182nd session

Proposal for the 03 series of amendments to UN Regulation No. 100 (Electric power trained vehicles)

Submitted by the Working Party on Passive Safety *

Figure 1
Schematic to Measure Wrap-Around Distance

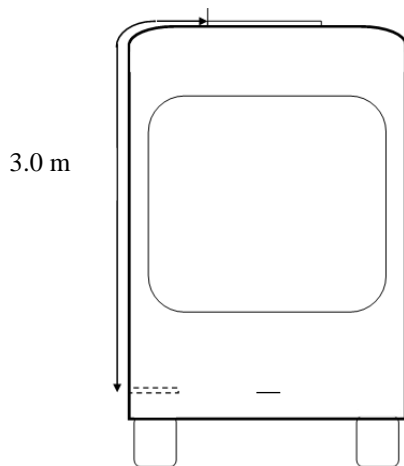
For vehicles of categories N₂, N₃, M₂ and M₃, conductive connection devices not energized except during charging of the REESS are exempted from this requirement if located on the roof of the vehicle out of reach for a person standing outside of the vehicle and, for vehicles of category M₂ and M₃, the minimum wrap around distance from the instep of the vehicle to the roof mounted charging devices is 3 m. In case of multiple steps due to an elevated floor inside the vehicle, the wrap around distance is measured from the bottom most step at entry, as illustrated in Figure 1.

Example of Test Method using DC Power Supply

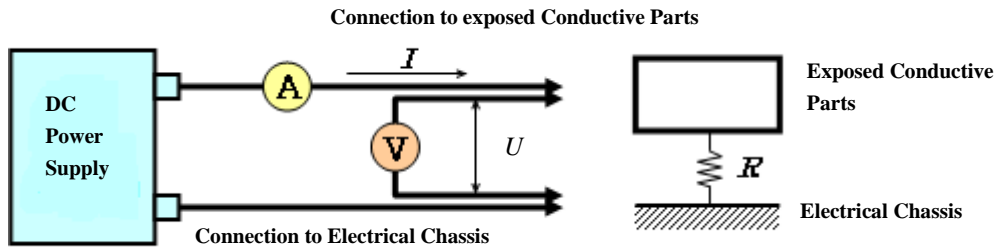
Figure 1, shall be deleted

Insert a new Figure 1, to read:

Example of the test method using DC power supply, voltmeter and ammeter is shown below.

Figure 1
Standard Nozzle for the Test

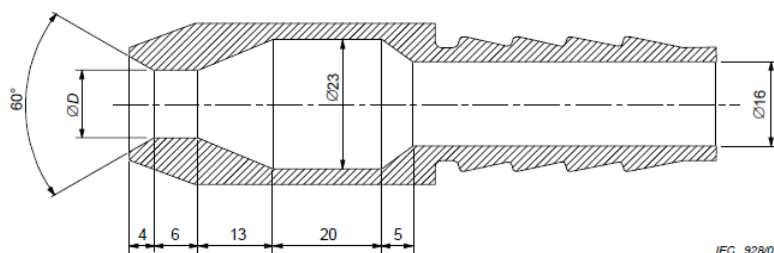
- 2.2. For electrical components, externally attached (e.g. in engine compartment), open underneath, both exposed or protected locations, the testing authority shall verify, with a view to confirming the compliance, whether the test is conducted by spraying the high-voltage component or system from all practicable directions with a stream of water from a standard test nozzle as shown in Figure 1. The following parameters are observed during the test in particular:

- (a) Nozzle internal diameter: 6.3 mm;
 - (b) Delivery rate: 11.9 – 13.2 l/min;
 - (c) Water pressure at the nozzle: approximately 30 kPa (0.3 bar);
 - (d) Test duration per m² of surface area of the tested high-voltage component or system: 1 min;

- (e) Minimum test duration: 3 min;
 - (f) Distance from nozzle to tested high-voltage component or system surface: approximately 3 m (this distance may be reduced, if necessary to ensure proper wetting when spraying upwards).

Figure 2
Splashing Test Nozzle

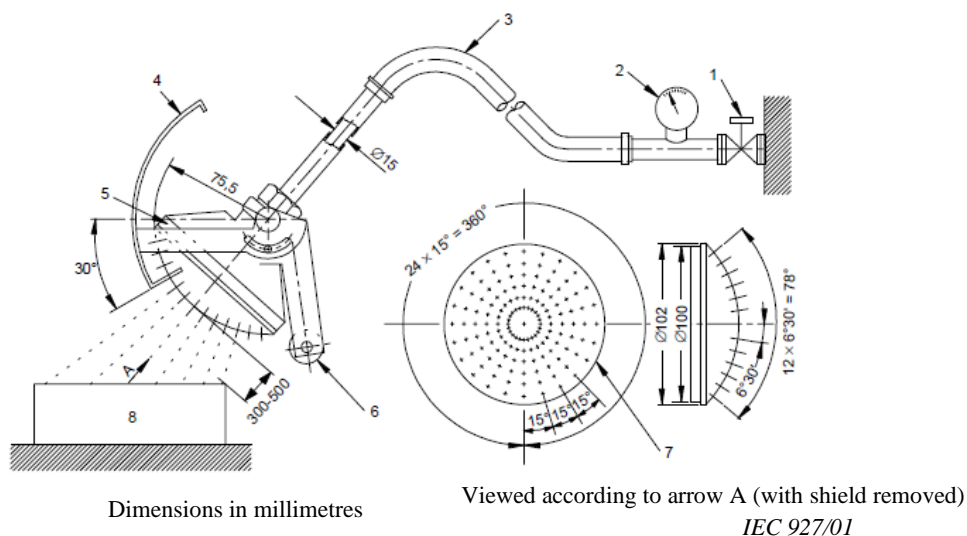
- (b) The test is conducted by using splashing test nozzle as shown in Figure 2;
- (c) The moving shield is removed from the spray nozzle and the machine is sprayed from all practicable directions;
- (d) The water pressure is adjusted to give a delivery rate of (10 ± 0.5) l/min (pressure approximately 80 kPa to 100 kPa (0.8 bar to 1.0 bar));
- (e) The test duration is 1 min/m² of calculated surface area of the machine (excluding any mounting surface and cooling fin) with a minimum duration of 5 min.
